Docket No. STN 52-001

Subject: **Submittal Supporting Accelerated ABWR Review Schedule - Resolution of
Outstanding Items of Section 3.11**

Enclosed are SSAR markups of selected portions of Section 3.11 supporting the
resolution of outstanding items.

Lower Drywell Integrated Dose from Noble Gas at various Leakages

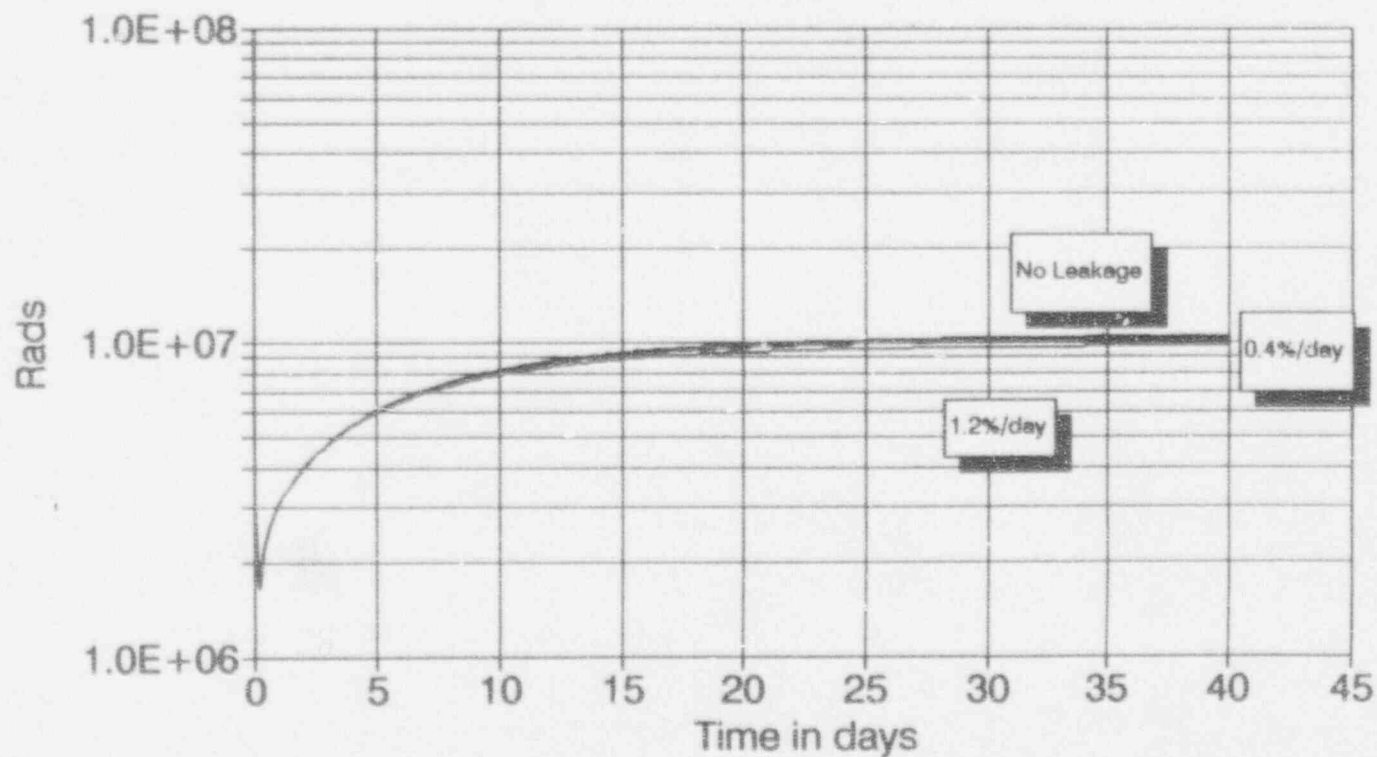
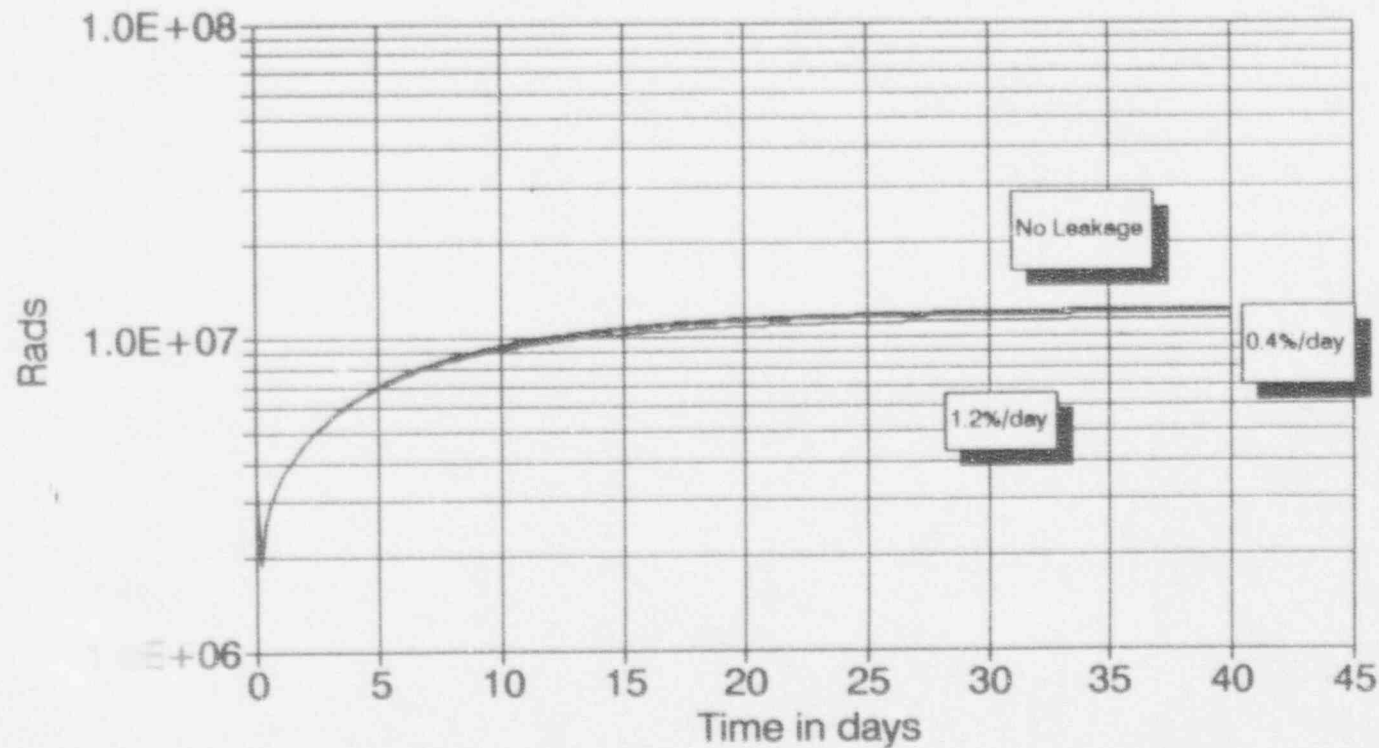
NRC Question: The staff noted in the DSER that the integrated gamma accident dose is in primary containment for the ABWR is given as 6×10^7 rads, which is less than the typical value of about 2×10^8 rads quoted in the safety analysis reports of several operating reactors (e.g. Perry: 2.7×10^8 ; River Bend: 1.7×10^8 rads; Clinton: 2×10^8 rads; Nine Mile Point: 1.4×10^8 rads). It is not clear why the ABWR integrated gamma accident dose is lower than the corresponding doses quoted for several operating reactors. GE's position which was provided in Section 5.3.2.1.5 of SSAR Amendment 15, did not adequately address this issue. To resolve this issue GE must fully explain why the ABWR integrated gamma accident dose is lower than the corresponding doses quoted for several operating reactors. This is Open Item 3.11.3-3.

Reply: The value of 6×10^7 rads originally reported in the ABWR SSAR is not the total integrated gamma dose for the primary containment for U.S. application but is the total integrated gamma dose as stipulated for the Kashiwaski 6/7 reactors being built and licensed under Japanese regulations. The difference between this value and the quoted existing U.S. reactors is one of philosophical approach between the two countries. To examine this difference we will compare the above ABWR calculation to that of the original TVA STRIDE design (BWR 6) which is shown in the following table.

In the ABWR, a preliminary calculation for the noble gases has been done and is shown in the attached figures. In all three figures we see that the integrated drywell dose approaches 1.2×10^7 rads in each of the three major primary containment volumes. In Stride, a single volume was used to contain all the fission product release whereas in ABWR there are three separately distinct volumes which are separated by meters of concrete. In ABWR it is possible that for a short time, on the order of hours, all the noble gases would be contained in a single volume, this would certainly not be the case for a 100 day evaluation. This short period containment has not been considered in the attached figures but will be in the final

evaluation. Therefore if a single volume (forcing all the release into a single volume for 100 days) were considered, the ABWR dose would increase an estimated factor of 2 to approximated 2.4×10^7 rads which is similar to Stride.
